Sent: 16/05/2022 4:09:35 PM
Subject: DA2021/1808 Submission | Brendan and Tracey Doyle of 11 Cheryl Crescent, Newport
Attachments: Ltr - Northern Beaches Council - Objection to DA2021 1808 in relation to 9 Cheryl Crescent Newport - 16-05-22 - 11 Cheryl Crescent.pdf;

YOUR REFERENCE: DA2021/1808
PREMISES: 9 CHERYL CRESCENT, NEWPORT

2. Our Clients have instructed us to lodge the following submission objecting to development application DA2021/1808 ("the DA").
3. The DA seeks consent for alterations and additions to a dwelling house. The Development Site is zoned E4 Environmental Living pursuant to the Pittwater Local Environmental Plan 2014 ("the LEP").

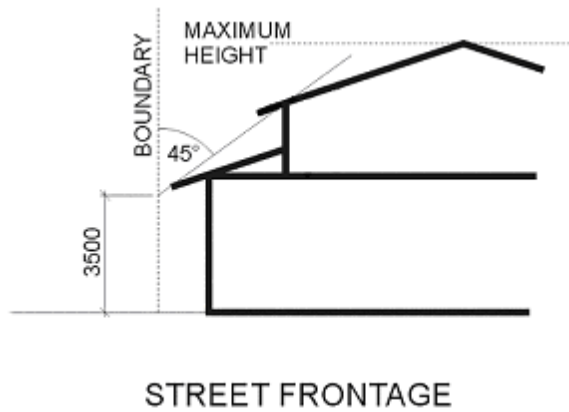
10. **Building Envelope** – A portion of the proposed first floor roof form encroaches on the building envelope contrary to clause D10.11 of the DCP. The north and east elevations in the amended set of architectural plans (DA9 and DA10) clearly show that the first floor has not been appropriately set back in accordance with Council's controls.

The SEE has not adequately addressed the detrimental impacts of this non-compliance to the amenity of our Clients' property, including bulk and scale (discussed at paragraph 6 above), acoustic privacy (paragraph 7) or view loss (paragraph 8). These amenity impacts need to be addressed through compliance with Council's building envelope controls.
